CITY OF HUBER HEIGHTS STATE OF OHIO City Council Meeting Regular Session August 8, 2022 6:00 P.M.

Case BDP 22-13 - Hartman I, LLC - Rezoning/Basic Development Plan - 7611 Old Troy Pike

Subject: Basic Development Plan Review – Medical Facility

Fire Assessment

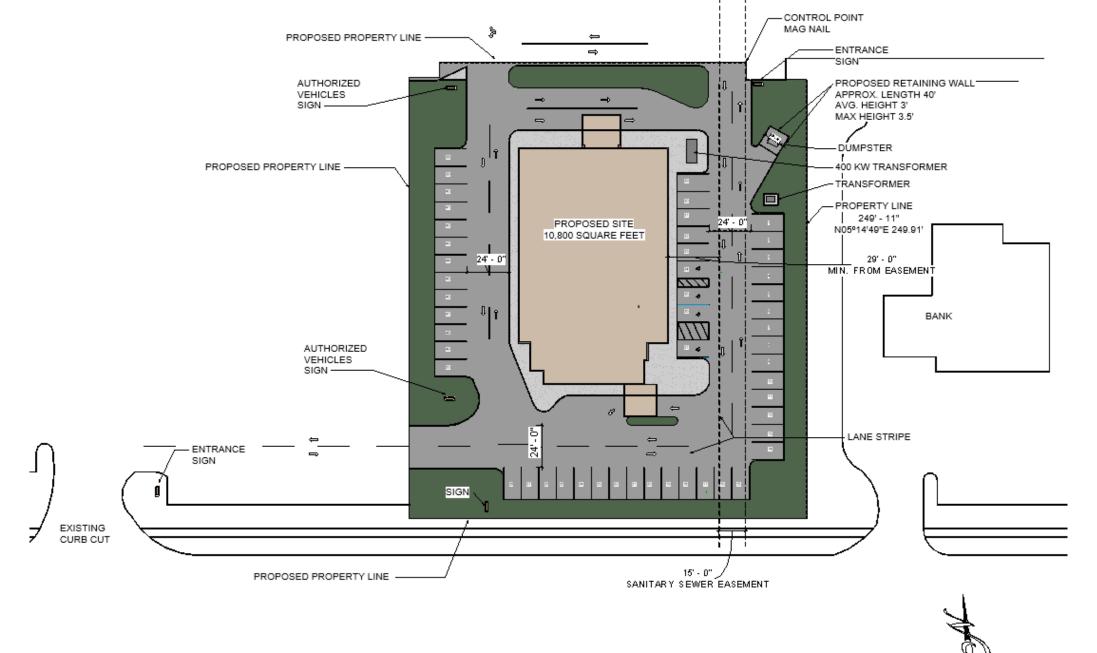
Plan submittal is approved as shown on drawing. Proposed use has not been clarified on drawing. Cover sheet indicates medical facility. Additional requirements regarding fire department access and fire hydrants may be forthcoming during development.

- Submitted drawing is not to scale, therefore turn radius for fire department apparatus access has not been verified.
- Site utility drawing has not been provided. Additional hydrants may be required.
- If building is to be sprinklered a hydrant will be required within 75 feet of the fire department connection. Huber Heights Codified Ordinance 1521.01(e).
